PLANS AND DOCUMENTS referred to in the PDA DEVELOPMENT APPROVAL

Approval no: **DEV2025/1634**
 Date: **25 July 2025**

AMENDED IN RED
By: Chessa Lao
Date: 2 July 2025

PROJECT TITLE: DEVELOPMENT APPLICATION PLANS FOR INDUSTRIAL UNITS
LOT 7 PART OF LOT 101 ON SP271601
LOT 7 FRANKLIN ST, YARRABILBA QLD

STORMWATER CATCHMENT PLAN
SCALE 1:100

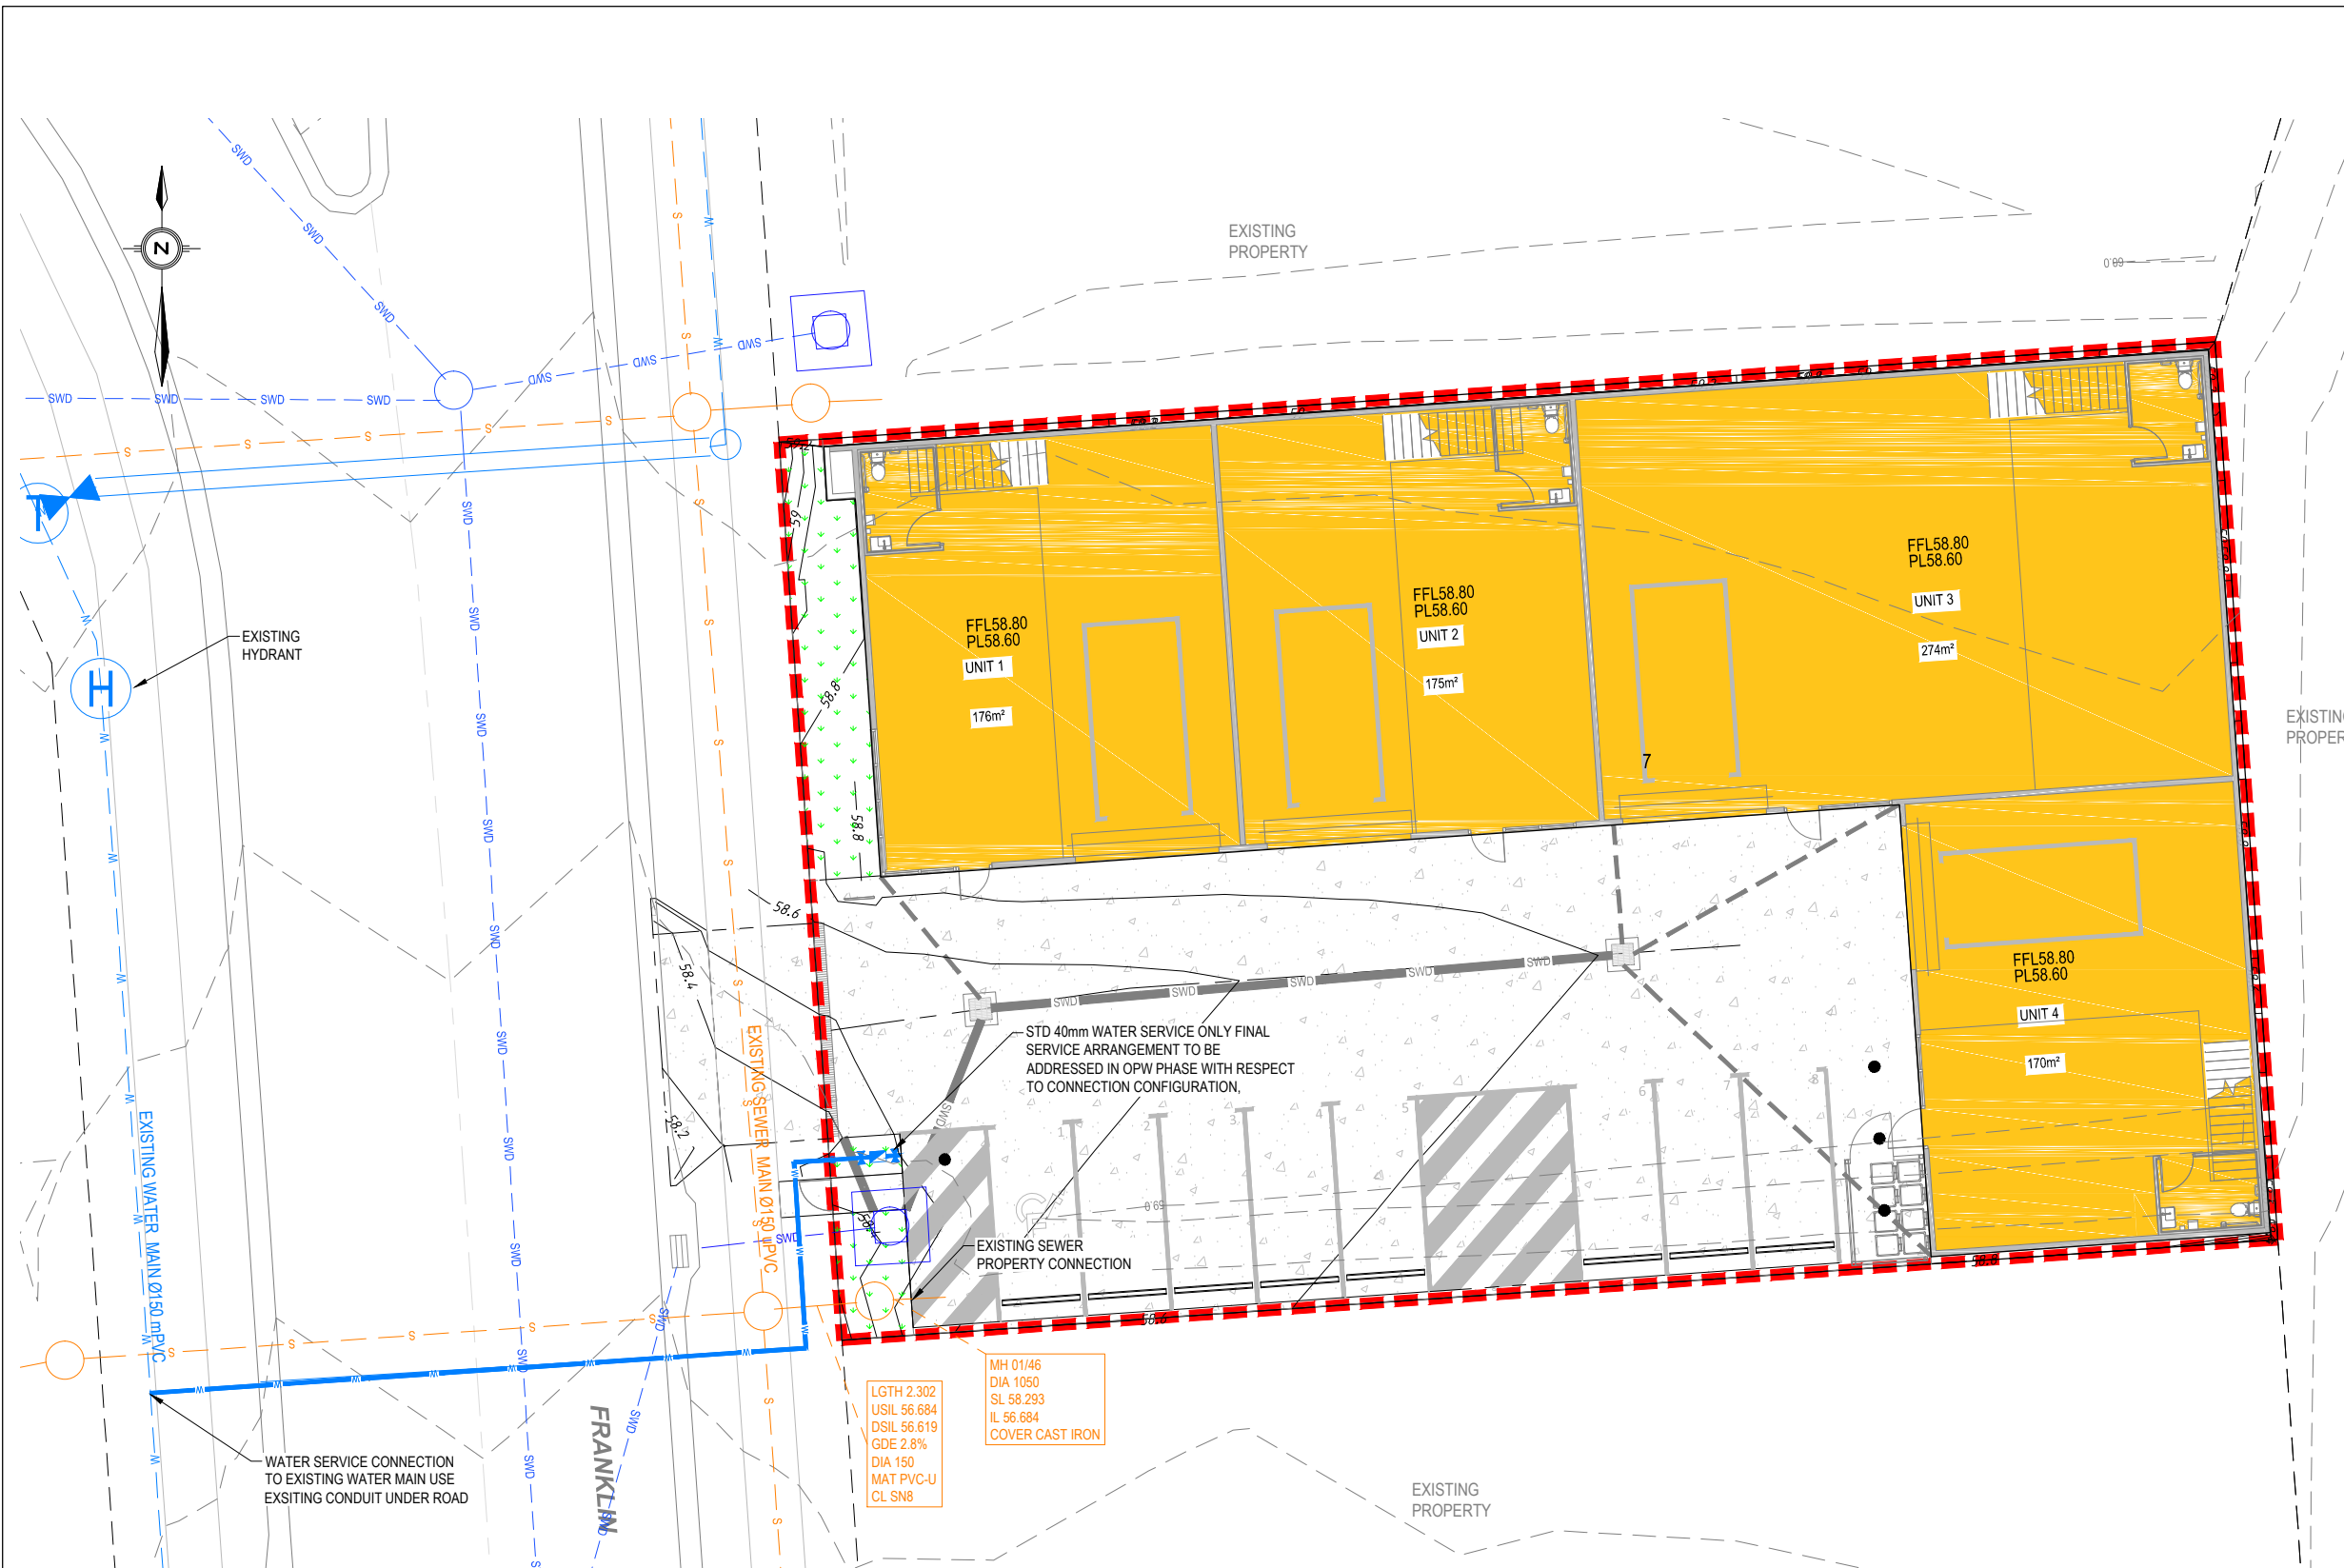
Include gross pollutant traps on all stormwater inlets to comply with State Planning Policy 2017, Appendix 2, Table A – Litter, Hydrocarbons and other contaminants. Any product specified is to be a verified product on the SQIDEP approved product list.
